Re: Indian Point Unit 2
Docket No. 50-247
NL-06-011

**Subject: Response to Request for Additional Information regarding
LAR for Pressurizer Level Requirements (TAC MC7061)**

**REPLY TO NRC REQUEST FOR ADDITIONAL INFORMATION REGARDING
PROPOSED LICENSE AMENDMENT REQUEST FOR
INDIAN POINT 2 PRESSURIZER WATER LEVEL REQUIREMENT**

FIGURE ONE - REPRESENTATIVE DENSITY COMPENSATION CURVE

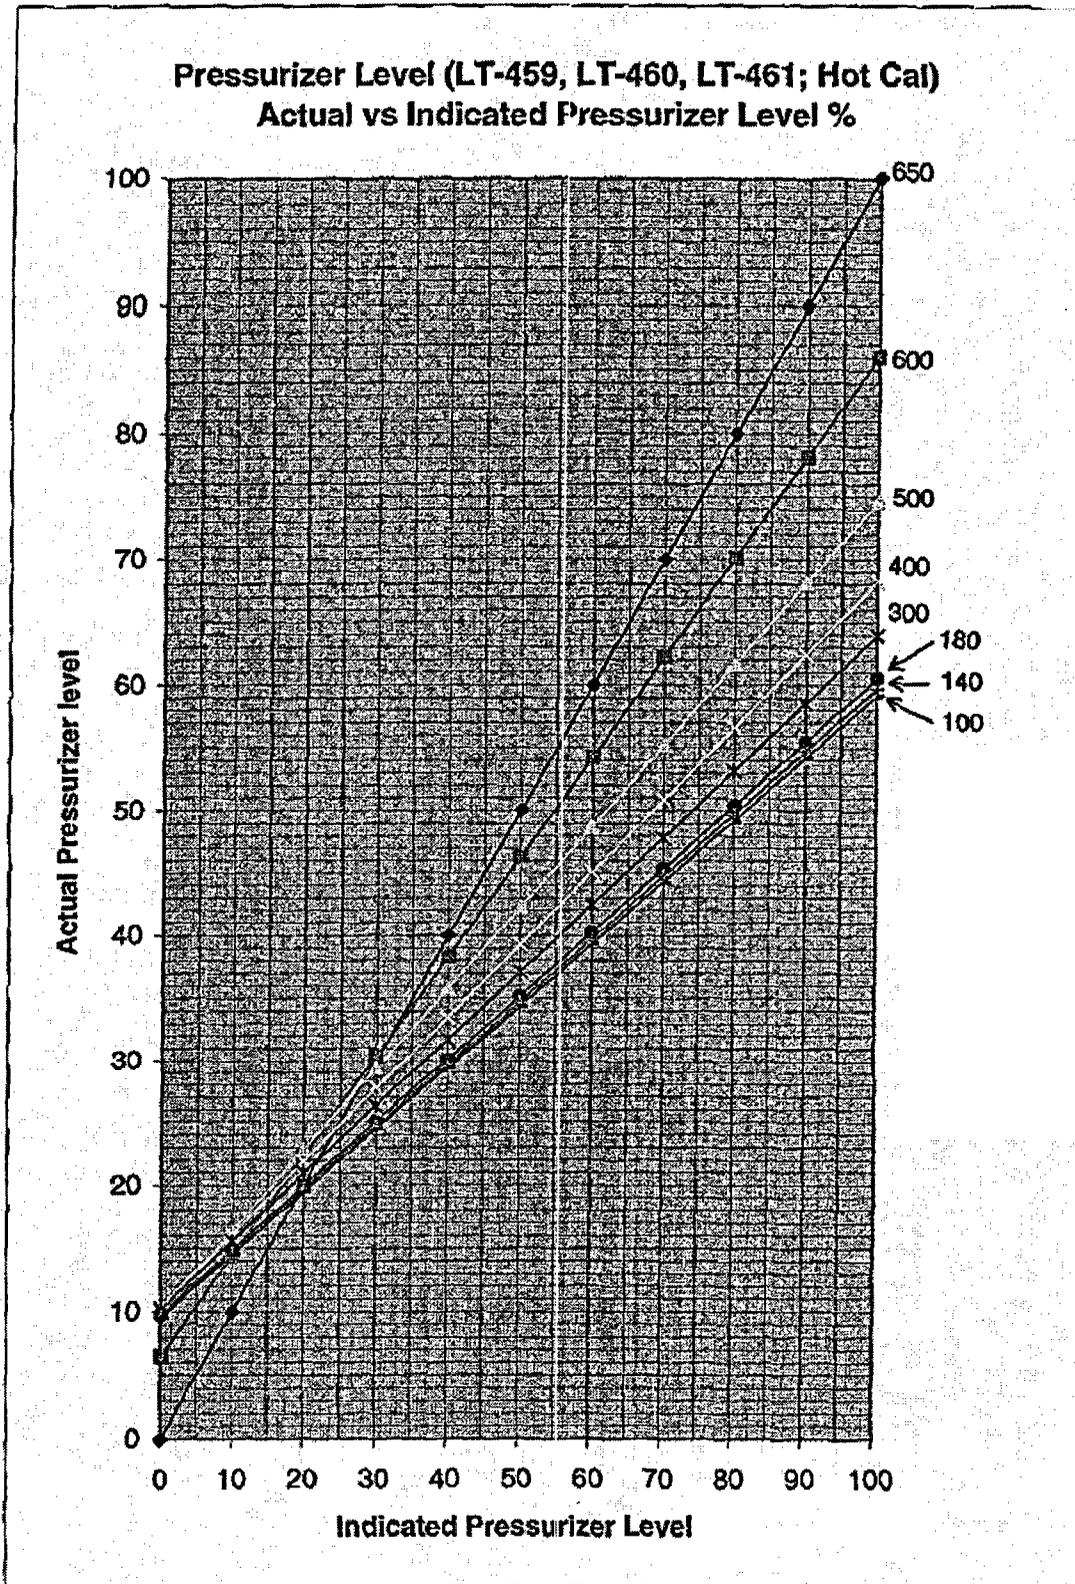
The licensee stated in its amendment request that the instrument channel indicators for the pressurizer level must be adjusted by plant operators using density compensation curves when the pressurizer is not at the temperature used for the instrument channel calibration. Since the temperature range for the Mode 3 operation is defined in the TSs, the licensee should be able to calculate the maximum uncertainty in the indicated pressurizer level under the most limiting Mode 3 conditions. The NRC staff requests that the licensee identify the maximum uncertainty, describe the methodology used to perform the calculation, and provide a technical justification for why this uncertainty is bounding.

The above instrument uncertainty values are valid for the full range of temperature, from a cold condition to normal operating temperature, as long as operators apply the applicable density compensation adjustment based on indicated fluid temperature in the pressurizer. Figure One is a sample density compensation curve for the hot calibrated instrument channels. Operating procedures are already in place that require operators to use density compensation curves if the process temperature is not at the calibration temperature for that instrument channel.

Therefore, when using the hot-calibrated channels, operators average the readings from two of the three indicators, apply density compensation if needed, and compare the result to the Technical Specification limit. When using the cold-calibrated channel, density compensation is applied if needed to the reading available from the single channel to compare to the Technical Specification limit. This approach is currently in place for the existing Technical Specification limit. This approach will also apply for the proposed new technical specification which establishes a new limit in Mode 3 that is different from the Mode 1 / 2 limit.
